**Re: SSD 9194 13-23 Gibbons Street Student Accommodation
Request for further information / Supplementary Response to Submissions**

Supplementary Response to Submissions

13-23 Gibbons Street, Redfern

SSD 9194

Figure 1: RTS and Proposed L3 plans showing setbacks to Margaret Street and improved alignment to Street. (source AJ+C Architects)

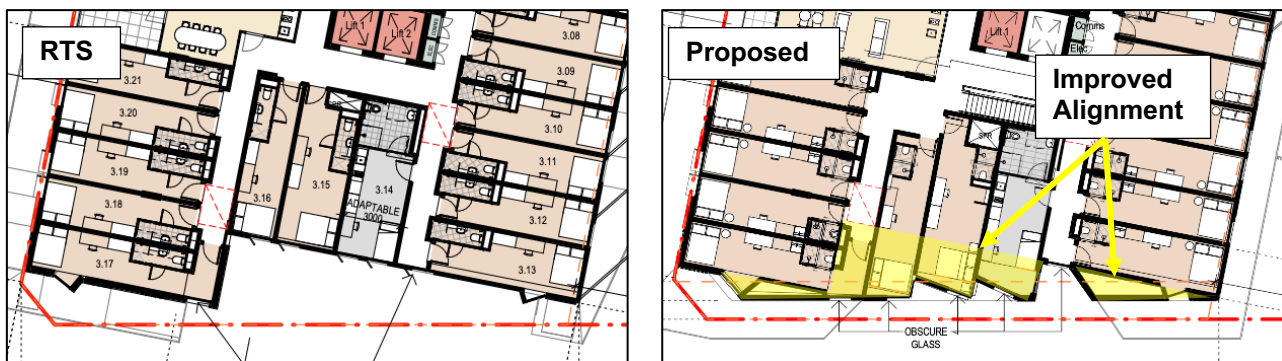
The podium footprint has also been redesigned on Margaret Street. The ground level setback has been further increased from .86m to 1.0m to improve footpath width. However, the podium facade has been realigned to create a more consistent street edge to Margaret Street. Note the comparison between the RTS scheme with the proposed scheme illustrated in **Figure 1**. No changes have been made to the tower setbacks but the amended podium results in a greater difference between the setback of the tower compared to the podium as shown in **Figure 2**.

- Redesign of the podium to better align with Margaret Street, provide a greater visual separation between the podium and the tower and to improve wind impacts, whilst still providing increased footpath width. Ground level setbacks would be increased from 0.86m to 1m (refer to **Section 2.1**)

Figure 2: RTS and Proposed L4 plans showing improved tower setback compared to podium. (AJ+C Architects)

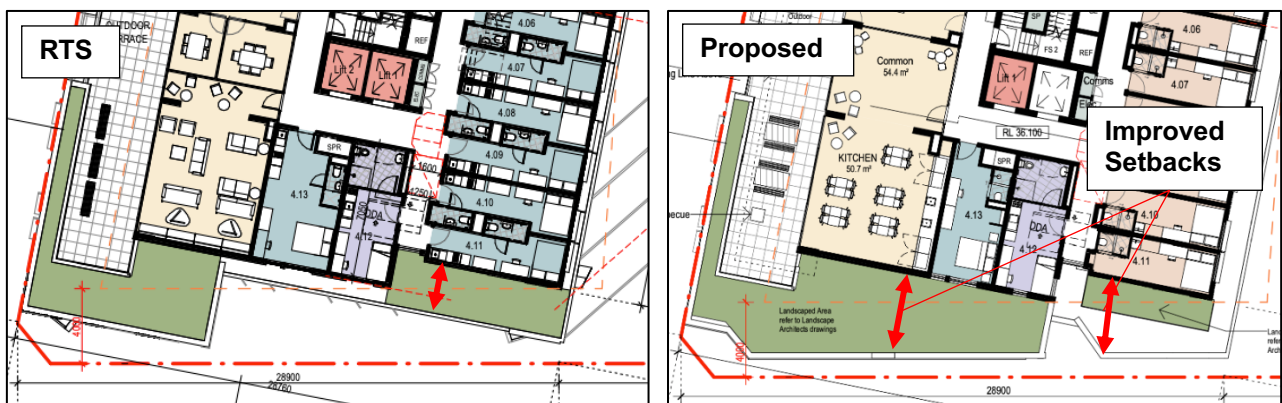
The greater separation also addresses concerns raised by the City of Sydney that a lack of tower setback in the RTS design would have created undue wind impacts as it would not deflect downdrafts from the tower. The proposed tower setbacks to the podium façade line would be between 3 and 6 metres and average setbacks would exceed 4 metres, ensuring a similar outcome to the built form envisaged by the controls while still enabling footpath widening and street tree planting.

This results in improved visual separation between the tower and the podium, which in conjunction with the reduced podium height, results in a superior pedestrian scale to this part of the site and a better visual integration with the lower scale development to the south. It also reinforces a street wall edge to the site, consistent with the Redfern Centre Urban Design Principles.

Figure 8: Proposed Revised Typical Tower Plan showing setbacks and window treatments on eastern elevation.
(source AJ+C Architects Revised Supplementary Design Report)

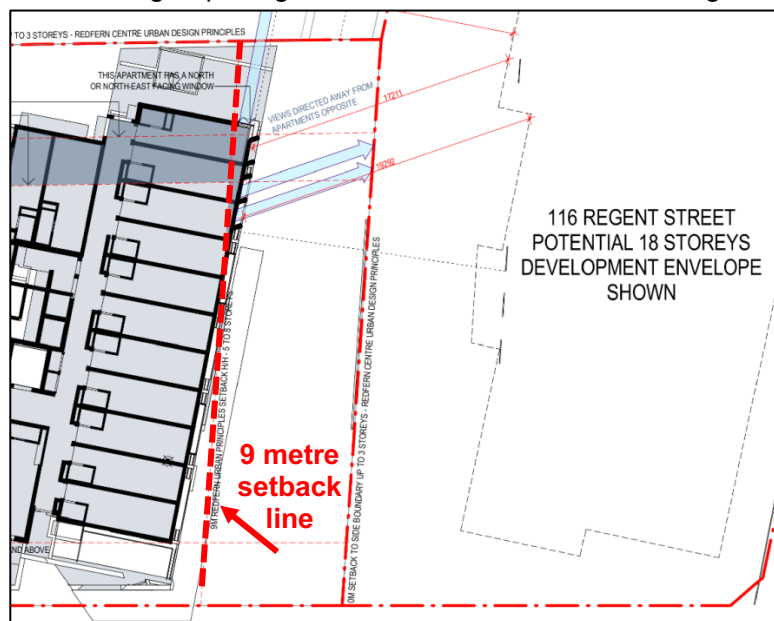
Issue: Review the proposed tower setbacks and potential privacy impacts given the eastern elevation includes habitable room windows less than 9 m from the boundary.

As seen below in **Figure 8**, the majority of habitable room windows in the eastern elevation would have a setback of more than 9 metres from the boundary. Only 3 windows on each level would be within 9 metres and setbacks would be between 7.85 and 8.37 metres.

To address the potential for any privacy impacts to future development from these windows, the northern most unit window is re-oriented and angled shades are proposed to remaining affected windows which would ensure the main line of sight to the boundary would exceed 9 metres. Refer to detailed discussion in the Supplementary Design Report in **Appendix C**.

Figure 10: Podium line within the Gibbons Street streetscape
(source AJ+C Architects Supplementary Design Report)

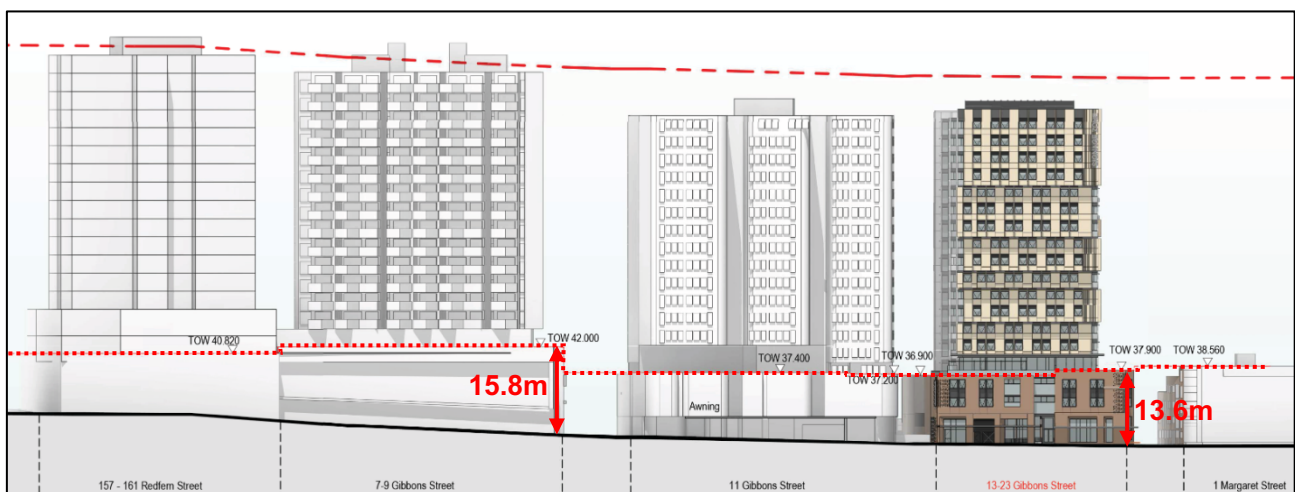
Issue: Provide an assessment and contextual analysis of the increased podium height in Gibbons Street, noting the Redfern Centre Urban Design Principles require podium heights to respond to the parapets/RLs of existing buildings to create symmetry/consistency across streets and laneways.

The proposal has been amended in the SRTS to reduce the Gibbons Street podium height by approximately 2 metres (from RL39.1 - 39.9 to RL36.9 - 37.9). The only adjacent street or laneway is Margaret Street and the podium had been designed to create symmetry with the height of the building on the opposite side of Margaret Street as required by the Principles (refer to **Figure 9**).

Although not specifically required by the controls, the podium height has also been amended having regard to comments from the City of Sydney so that it now steps in height to create a better visual connection with the approved podium height of 11 Gibbons Street, adjoining the site to the north.

As requested by the Department, an assessment and contextual analysis has also been carried out to examine the podium height in Gibbons Street having regard to other development in the streetscape. As seen in **Figure 10**, the street includes a significant variation in podium heights and the proposed development easily falls within the range of approved podiums heights. With a maximum proposed height of 13.6m fronting Gibbons Street, the proposed podium would remain materially smaller than the podium at 7 - 9 Gibbons Street which was approved with a maximum height of 15.8 metres.
